## PLANNING AND DEVELOPMENT SERVICES STAFF REPORT

**SUBJECT: Speedway Site Plan for City Council Approval  
(1300 North Maple Road)  
File No. SP11-037**

**SUBJECT: Speedway Site Plan for City Council Approval  
(1300 North Maple Road)  
File No. SP11-037**

**LANDSCAPE PLAN  
 REBUILD**  
 MAPLE ROAD AND MILLER AVENUE  
 WASHINGTON COUNTY  
 ANN ARBOR, MICHIGAN

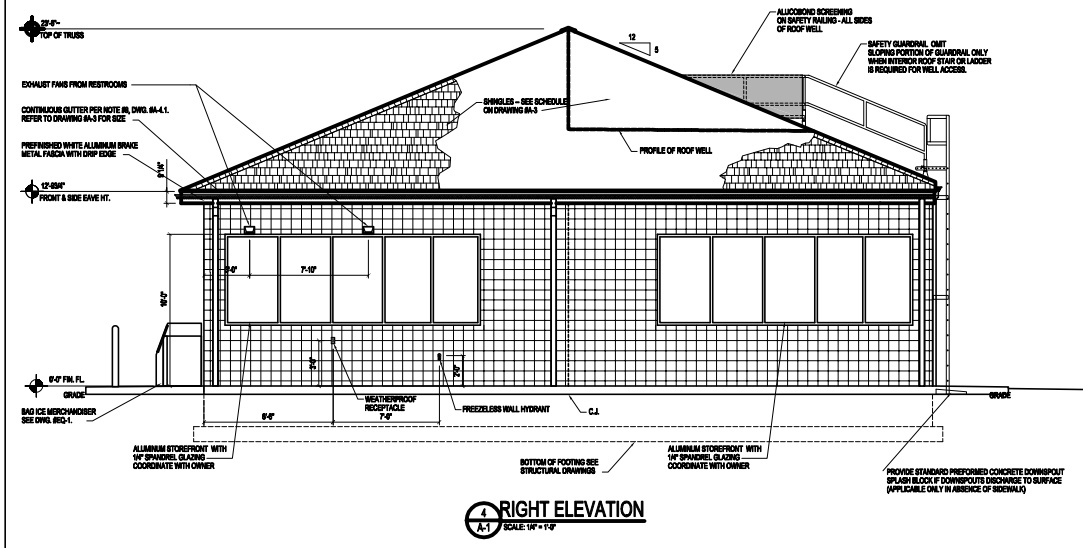
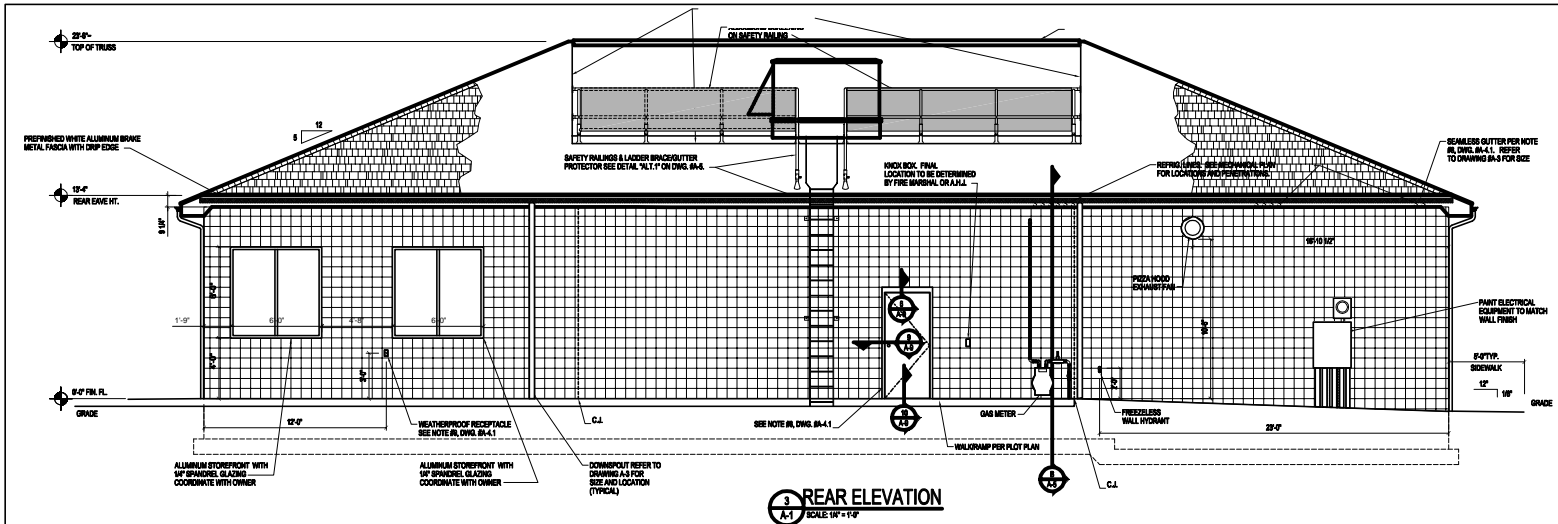
conflicting land use buffer. Staff had received a comment from a neighbor to the east requesting that the existing buffer be left in place in order to screen the adjacent residential neighborhood. While much of the existing buffer is composed of non-native vegetation, it does constitute an established dense vegetated buffer that benefits the adjacent property owners more than removal of the existing trees and the planting of much smaller plant materials.

Systems Planning (Landscaping) - The proposed plan does not meet the standards for interior parking or conflicting landuse buffer requirements. The petitioner would like to use much of the existing vegetation along the eastern boundary, but this request does require a Landscape modification to be approved by Planning Commission. The petitioner and staff will continue to work together to make revisions to the plan and the petitioner will submit the application for a Landscape modification if plan revisions still require modification approval.

*No disturbance of the existing vegetation is proposed in the buffer. Removal of the vegetation & replacement per the requirements would result in less screening than what exists today. The preservation of the existing trees & shrubs meets the spirit of the Code and provides a good buffer to the neighboring properties.*

*The quantity of preserved trees and buffer width exceeds the code requirement. Although the existing trees are primarily deciduous and do not meet the 50% evergreen requirement and maximum spacing requirement, the existing buffer provides a naturalized dense shrub barrier equivalent to the hedge requirement while providing tree clearance from an existing overhead electric line that crosses a portion of the buffer.*
